EI - 21013

RE: Cates Landing
Randall Rhodes

PROJECT NO. _____	
DRAWN BY _____	
DESIGN LEADER _____	
CHECKED BY _____	
REVIEWED BY _____ (PROJECT MANAGER)	
DATE 02-02-15	
SHEET RRI.1	
RAIL ROAD RIGHT OF WAY NORTHWEST TENNESSEE REGIONAL PORT AUTHORITY CATES LANDING, TENNESSEE	
FORUM LANNON CORPORATION 250 US Hwy. 51, Bypass S., Dyersburg, Tennessee 38024 PH: (731) 257-4700

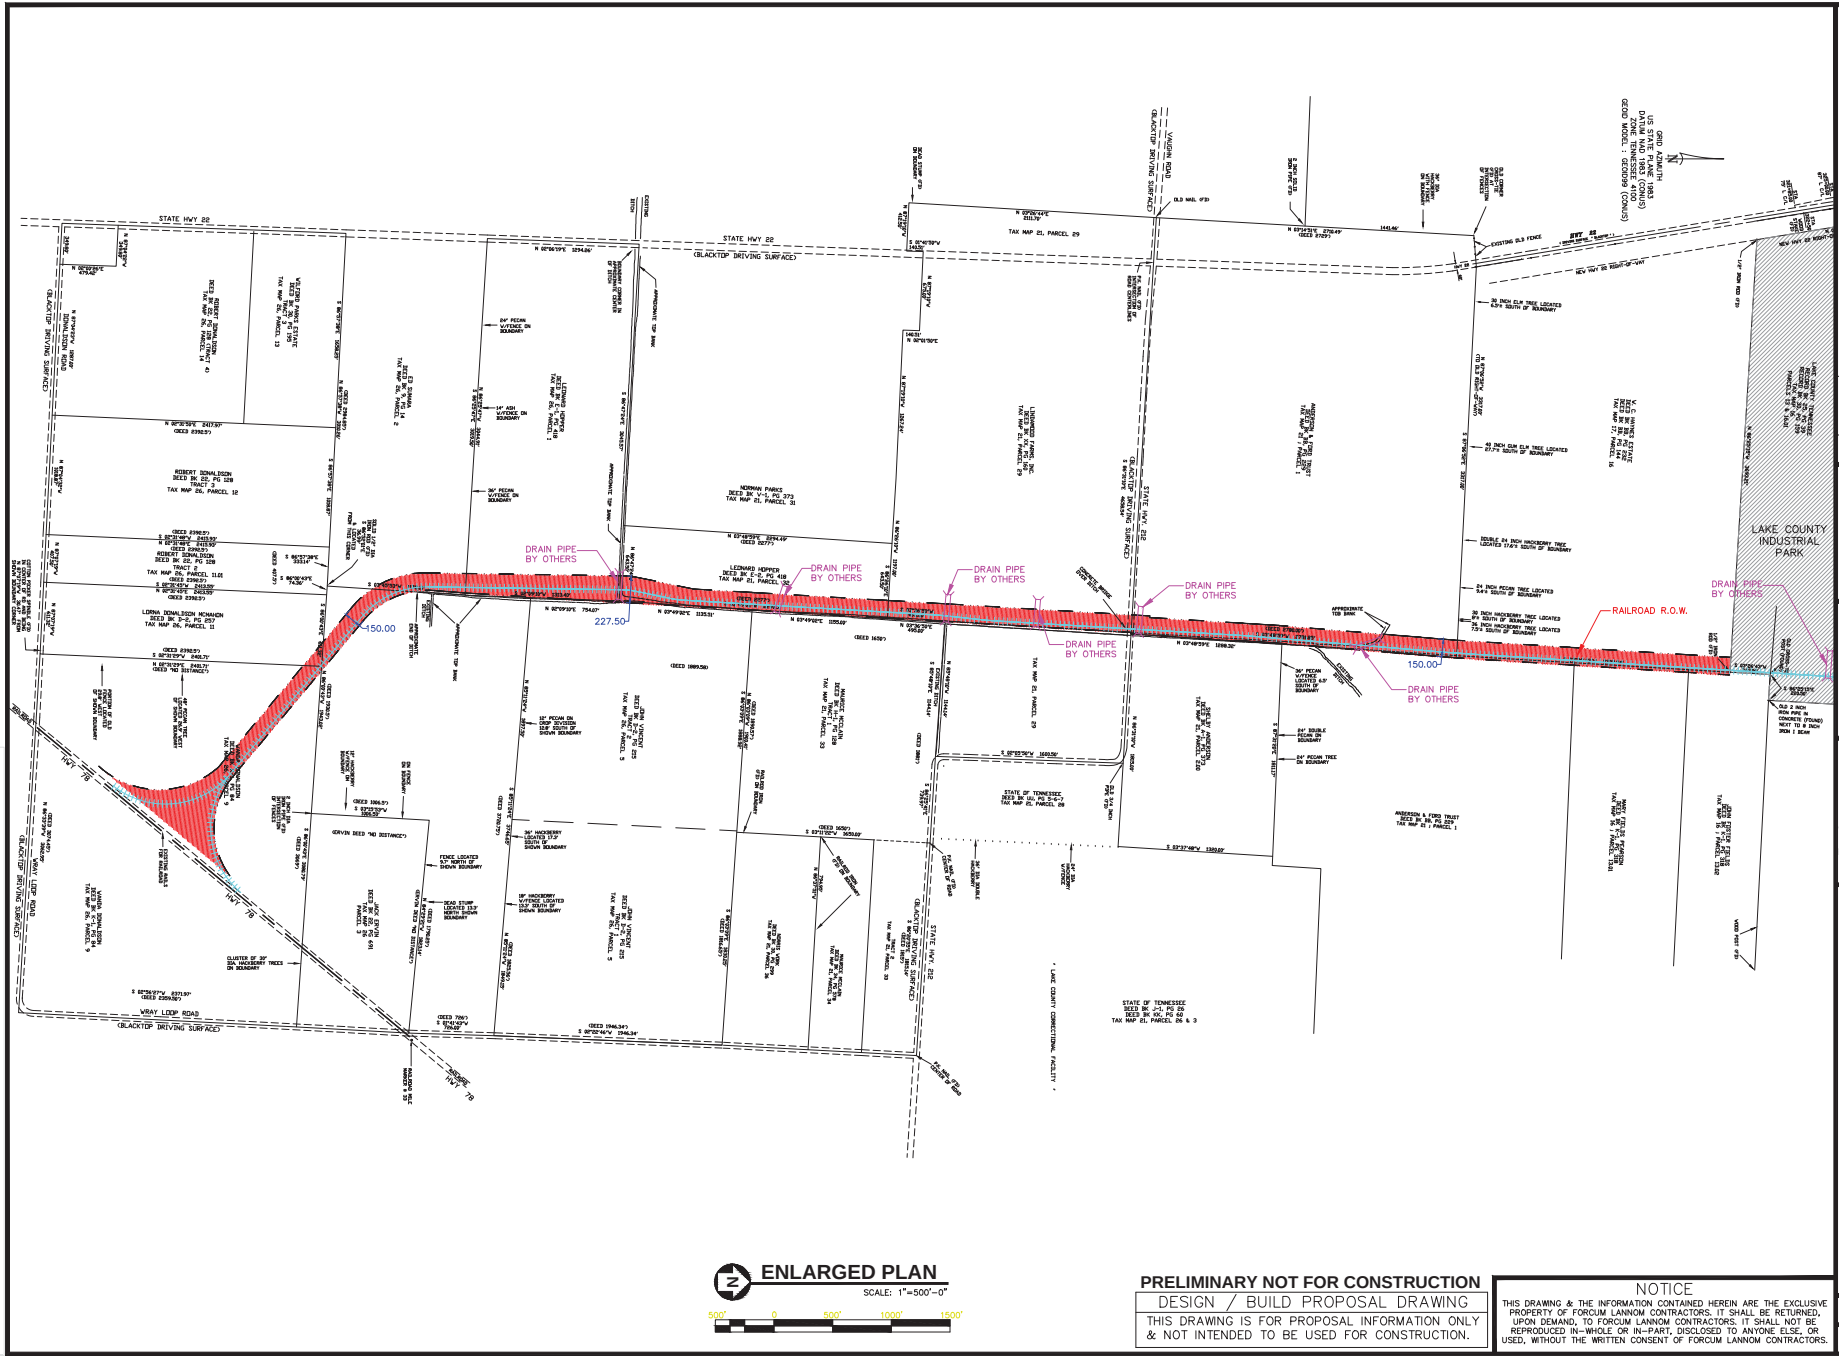
1. The likely width of right of way (minimum and maximum)

2. Any available information about culverts, bridges, or other structures

Answer: The first attachment labeled "Railroad R.O.W. – RR1.1" indicates the proposed R.O.W. shaded in RED. The R.O.W. width is indicated by blue dimensions and is typically 150 feet wide (minimum) but varies to a maximum of 227.50 feet where the proposed rail would cross the main drainage ditch. The R.O.W. would also include all the land inside of the delta (see map) at the existing short-line railroad connection due to the impact to the landowner's property.

Answer: The first attachment "Railroad R.O.W. – RR1.1" indicates by text and symbol the location of the foreseen culverts (called out drain pipes). A box culvert may be required at the crossing of State Hwy 212 where an existing concrete bridge over ditch exists (noted on the map). This ditch parallels the proposed rail line and would not be crossed, but a smaller feeder ditch will be crossed by the proposed rail line at this location. As to rail bridge there would likely be one required at the wider R.O.W. portion where the main drainage ditch is being crossed.
